Hornsea Project Four

Applicant's comments on Natural England's Comments received at Deadline 2

Deadline: 3, Date: 21 April 2022

Document Reference: G3.17

Figure 1: Pup/Juvenile Grey Seal Telemetry Tracks Connectivity with SACs.

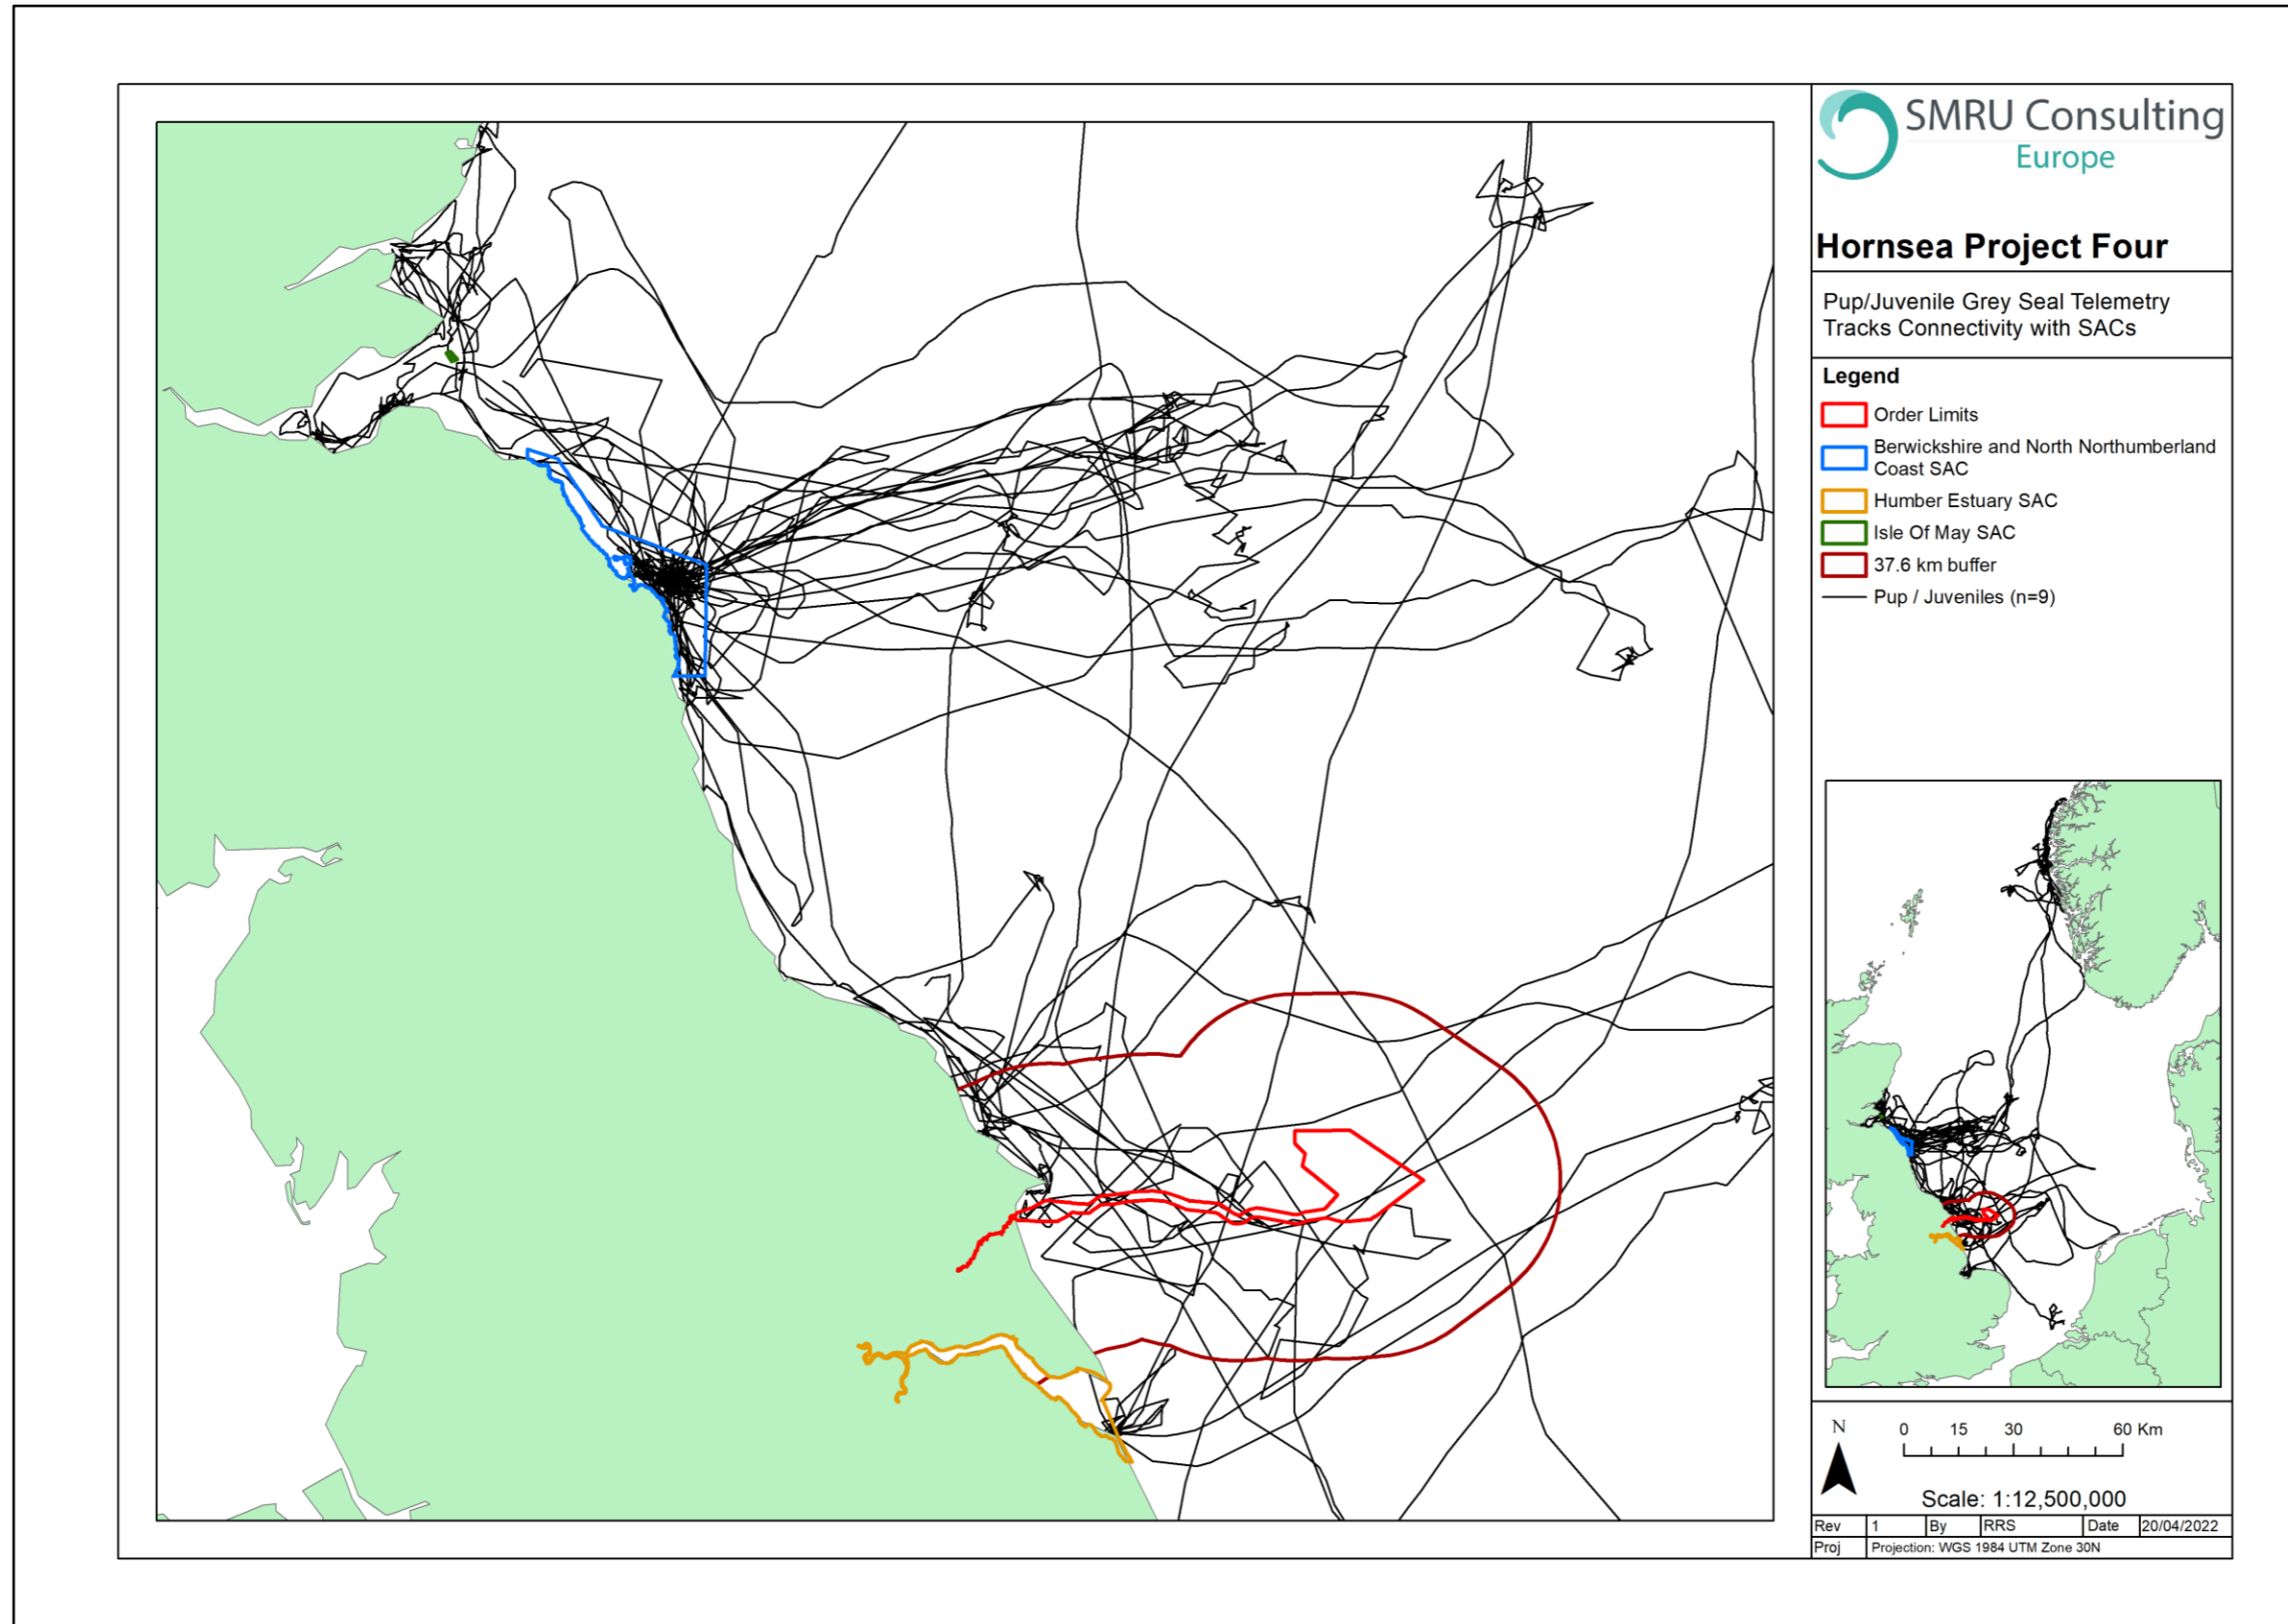
Reference	Stakeholder's Written Representation	Applicant's Response
	<p>Natural England maintains that mitigation should be committed to at this stage. This concern has not been resolved.</p>	
<p>D22: Report to Inform Appropriate Assessment</p>	<p>"We have provided clarification to the Applicant on the inclusion of geophysical surveys in the RIAA and anticipate further information at Deadline 2 on this. Please also see Points 13 and 15 regarding the inclusion of geophysical surveys in assessments.</p> <p>We have provided clarification to the Applicant on the inclusion of geophysical surveys in the RIAA and anticipate further information at Deadline 2 on this. Please also see Points 13 and 15 regarding the inclusion of geophysical surveys in assessments."</p>	<p>Please see the Applicant response to D12 from the Marine Mammals tab of the Natural England Risk and Issues Log above.</p>
<p>D23: RIAA (Appendix G)</p>	<p>A figure of the movements of the 9 tagged pups and juveniles should be presented, in order to better understand the movements of these life stages and the difference in movements compared to adult seals. Pups and juveniles are part of the protected feature of the site as well as adults.</p>	<p>There were 9 pup/juvenile grey seals that had telemetry data within the Hornsea Four area. Of these, seven showed connectivity with the Berwickshire and North Northumberland SAC, two showed connectivity with the Humber SAC and one showed connectivity with the Isle of May SAC. A figure is presented in Appendix A of this document.</p>
